**TITLE:** SPECIAL PERMIT NO. 622F, an amendment to THE VILLAS AT LAKESIDE COMMUNITY UNIT PLAN, requested by Ross Engineering on behalf of Craig Bauer Construction, to change from 130 units in 5 apartment buildings to 54 townhouses on individuals lots, with associated waiver requests, on property generally located at Lakeside Drive and West Lakeshore Drive.

**LINCOLN CITY/LANCASTER COUNTY PLANNING STAFF REPORT**

**P.A.S.:** Special Permit 622F

The Villas at Lakeside Community Unit Plan

**SITE PLAN**

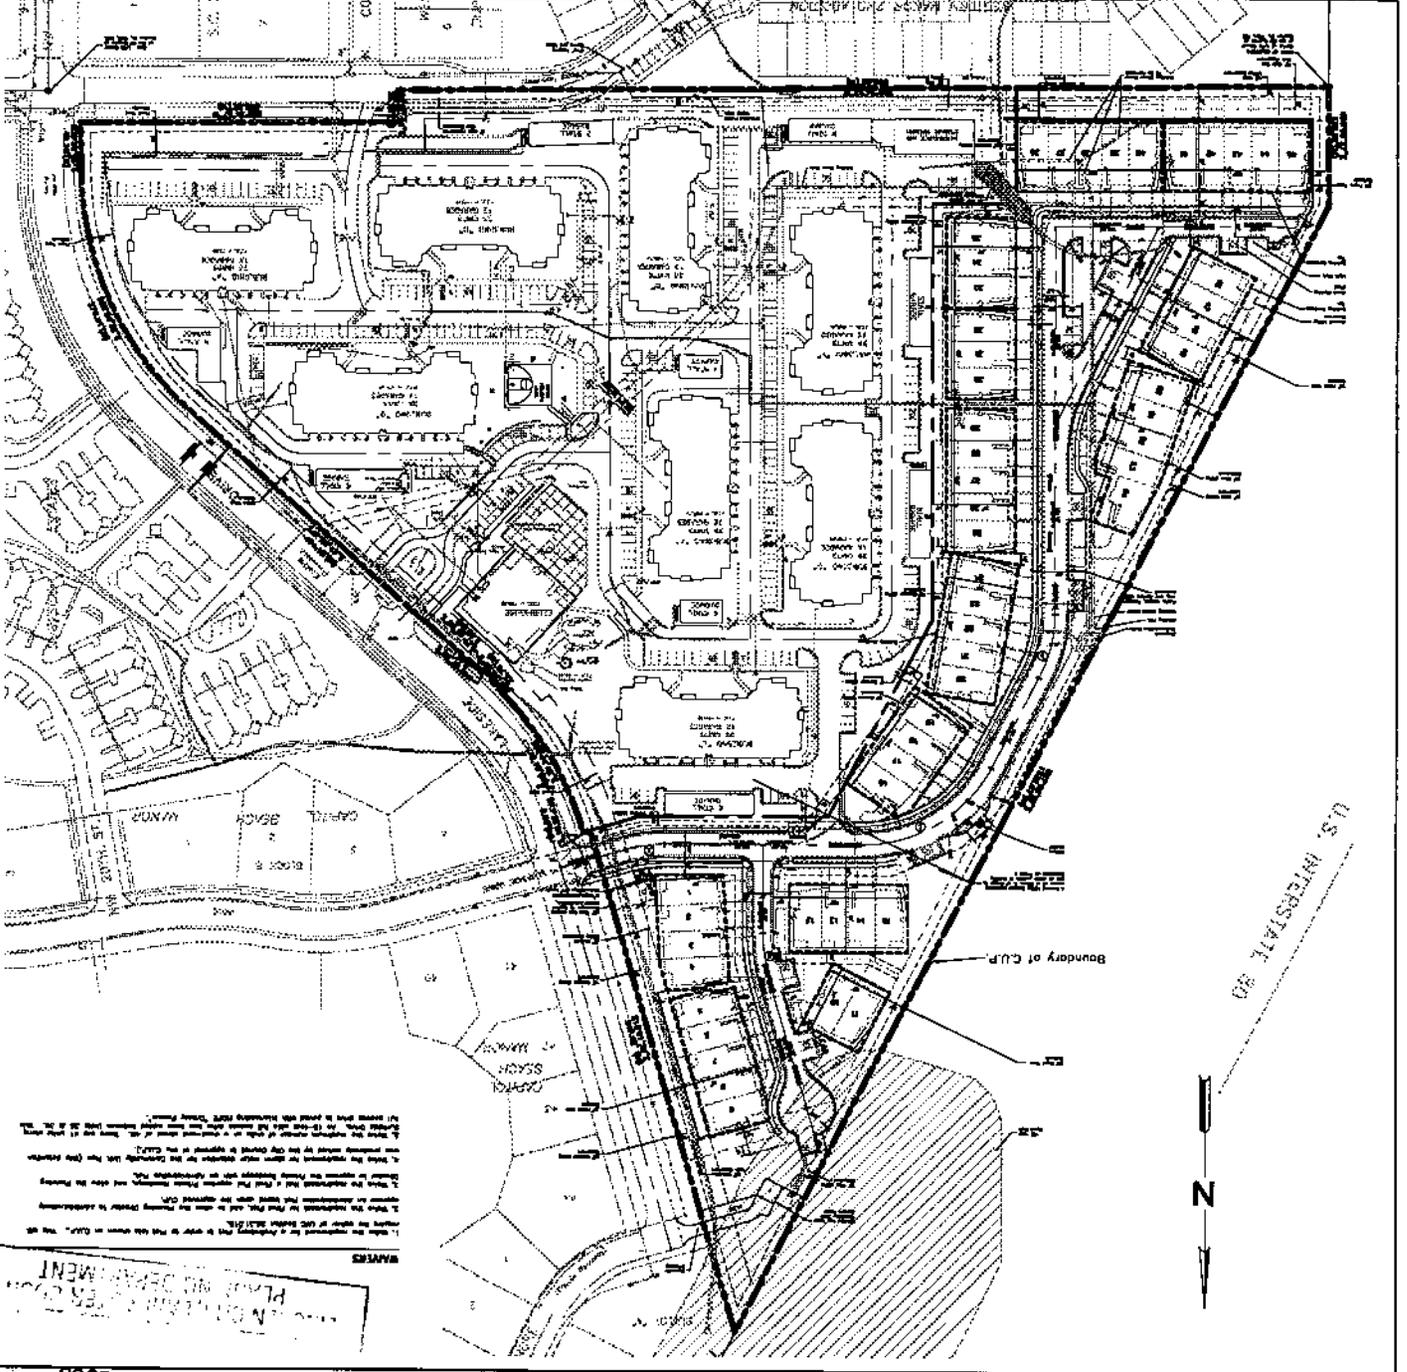
- a. The emergency access drive shown on southeast corner of the addition, Note 23. This connection needs to be a permanent access from the existing parking lot to the street system on Surfside Drive to provide an additional vehicle route because of the length of the dead end roadway.

- b. The profile and plan do not agree on the paving width of Surfside Dr. A 24' width is required. The profile at Surfside Court shows a 21' width.
  - c. Surfside Court is labeled Surfside Drive on the Plan Sheet.

4. Sanitary Sewers - The sanitary system as submitted needs to be revised to extend further north in Surfside Circle to provide frontage to the proposed lots. The grades as shown are reverse to the street grades in Surfside Circle. Justification will be required for the reverse grades.

5. General - Notes 2 and 28 are redundant. Notes 5 and 25 are redundant. Note 7 should read "Public Sanitary Sewer Mains will be constructed by Executive Orders," not a Plumbers Permit. Note 16 is unclear. Note 23, change "emergency driveway connection" to read "Full Access."
6. The Nebraska Department of Roads should be provided the opportunity to review the grading along the west side of this addition that abuts Interstate 80.
7. The Storm Water Detention requirement was waived with the original permit. However, the maintenance of the storm sewer outfall at the sedimentation basin, or additional upgrading will be required at the time of the final plat with a bond to be determined.

1. Show only necessary details on the Drainage Plan. Non-essential information added makes the plan very difficult to review.
2. Detention is required for this site. A drainage study must be included to show that post-developed conditions do not exceed pre-developed conditions.

4. The preliminary plat shows storm drain system under several buildings. If the storm drain system is not in the street an easement must be designated. The 100 year flow path must also be studied to show that it does not impact adjacent lots. This would include showing minimum opening elevations for lots adjacent to the flow path.

- 1.1.1 All waivers shall be listed on the site plan.
- 1.1.2 An additional permanent access shall be provided along Surfside Drive to accommodate the long length dead-end.

- 1.1.3 The street profile and site plan sheets shall be revised so they show the proper paving width of Surfside Drive
- 1.1.4 Surfside Court shall be labeled on the site plan.

- 1.1.5 A water main plan shall be submitted that is acceptable to the Public Works Department.
- 1.1.6 A sanitary sewer system shall be submitted that is acceptable to the Public Works Department. Since there is no request to waive the requirement that sanitary sewer lines run parallel to street grades, the lines may not run reverse to street grades as shown on the drawings.

- 1.1.10 Note 23 should be changed from "emergency driveway connection" to Full Access."
- 1.1.11 Add a note stating that maintenance of the storm sewer outfall at the sedimentation basin, or additional upgrading will be required at the time of the final plat with a bond to be determined.

- 1.1.12 ~~Submit a drainage study to show post-developed conditions do not exceed pre-developed conditions.~~ Submit drawings that conform to the stormwater detention requirements of the Land Subdivision Ordinance. **(\*\*As revised by staff in response to comments from the NRD, NDOR and Game and Parks Commission, and approved by Planning Commission: 4/30/03\*\*)**

- 1.1.13 ~~Demonstrate to the satisfaction of the Public Works Department that the area downstream of the stormwater outlet along the northwest limit of the GUP has the ability and capacity to drain.~~ Provide a water quality retention facility capable of holding a 2-year storm event for 24 hours. **(\*\*As revised by staff in response to comments from the NRD, NDOR and Game and Parks Commission, and approved by Planning Commission: 4/30/03\*\*)**
